## New Model Introduction

New model GR-6200-000 is offered as a direct replacement for model GC29403A. Models have common mounting and tooling and are dimensionally the same.

### Gen 5 Model GR-6200-000 (8.31458-2)

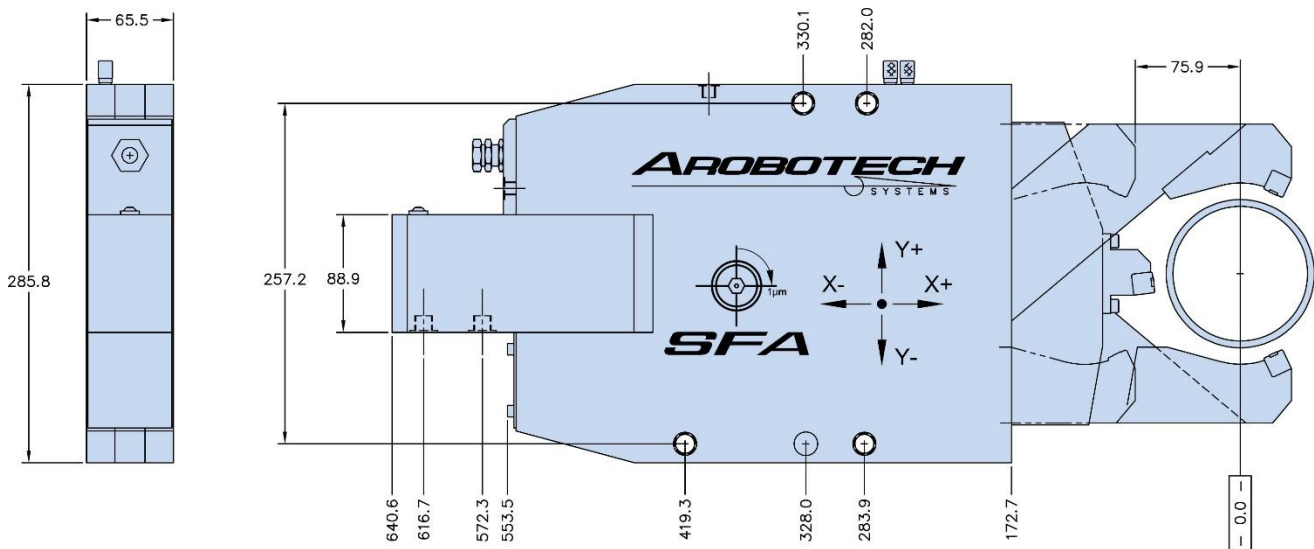
- \* Max Clamp Size = 130mm Diameter
- \* 20.3 cm<sup>2</sup> Piston Area
- \* 90° Turn = 0.001mm Adjustment (both axis)
- \* +/- 0.200mm Total Adjustment (both axis)

- \* Max Clamp Size = 130mm Diameter
- \* 20.3 cm<sup>2</sup> Piston Area
- \* X-Axis = 3.1° Turn = 0.001mm Adjustment ▪ ±0.22mm Total Adjustment
- \* Y-Axis = 10.4° Turn = 0.001mm Adjustment ▪ ±0.07mm Total Adjustment
